DOCKET NOS. 50-266 AND 50-301
ADDITIONAL INFORMATION - IE BULLETIN NO. 80-04
ANALYSIS OF PWR MAIN STEAM LINE BREAK
WITH CONTINUED FEEDWATER ADDITION
POINT BEACH NUCLEAR PLANT, UNITS 1 AND 2

ADDITIONAL INFORMATION REQUEST
IE BULLETIN NO. 80-04
ANALYSIS OF PWR MAIN STEAM LINE BREAK
WITH CONTINUED FEEDWATER ADDITION

FIGURE 14.2.5-a

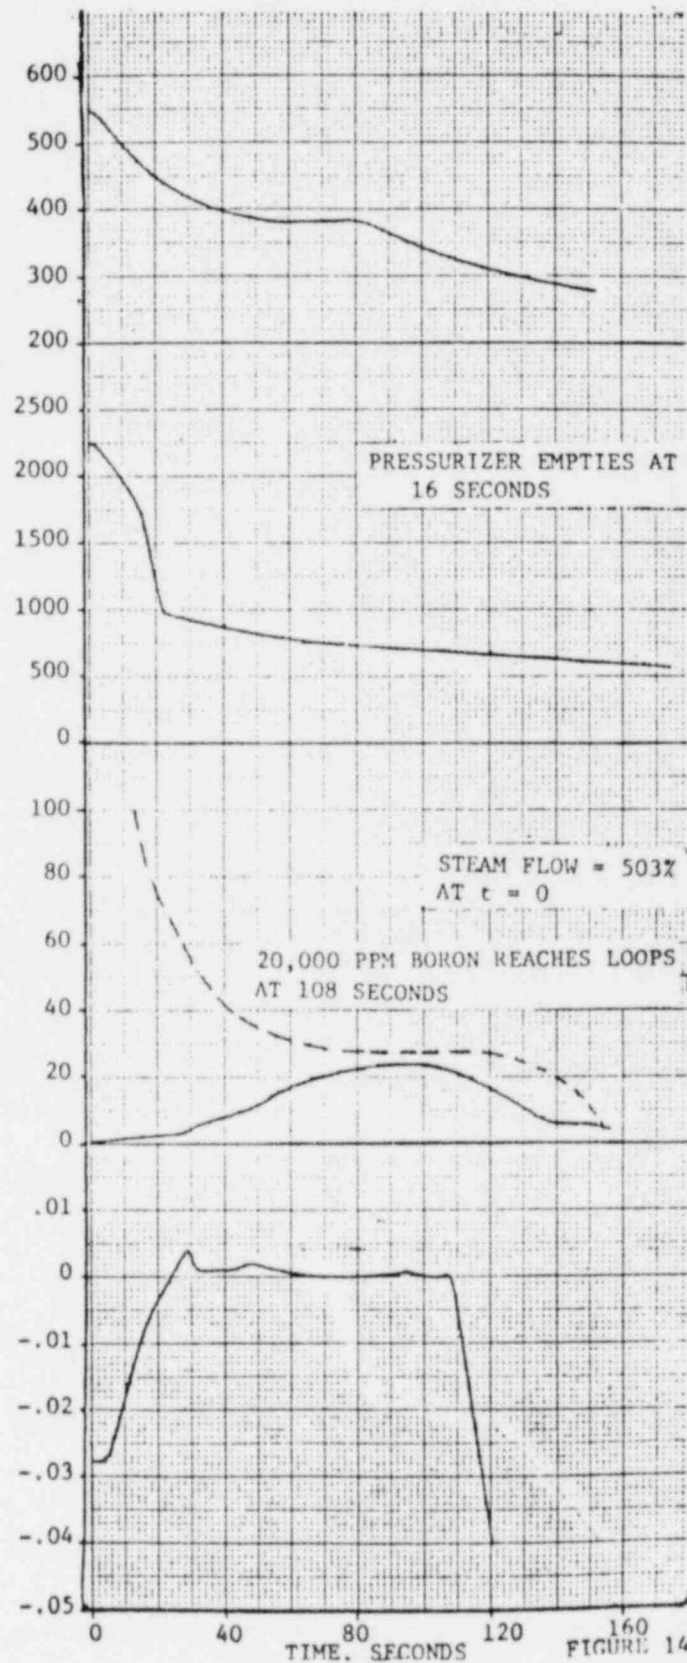
3. Your submittal of April 25, 1980 alludes to operator action but does not state what actions are required to

be taken and at what time the action is required. Provide this information and the justification for the time assumed for operator actions.

4. If your analyses requires operator action to mitigate the containment pressure consequences of the MSLB, provide the time when containment design pressure will be exceeded, if no operator action is taken. Provide also the magnitude of the peak pressure and the time at which the peak occurs.

Direct operator action is not required to prevent overpressurization of the containment. As discussed in the Point Beach FFDSAR analysis for the MSLB, safety injection would be automatically initiated early in the transient as a result of low steam line pressure (Technical Specification setpoint is ≥ 500 psig), well in advance of the time where the additional feedwater flow becomes important. Safety injection would also automatically initiate operation of the containment air recirculation fan coolers. Figure 14.3.4-1 (attached) of the Point Beach FFDSAR demonstrates that the fan cooler heat removal is more than adequate to remove the additional energy discharged into the containment by continued auxiliary feedwater addition, at the conservative rate discussed above, for an indefinite period of time. Also the containment spray system is automatically initiated when containment pressure reaches 25 psig during the initial blowdown transient. Operator action is not required to prevent containment pressure from exceeding its design value of 60 psig. However, as stated in our April 25, 1980 letter, operational procedures call for isolation of the auxiliary feed flow to the affected steam generator.
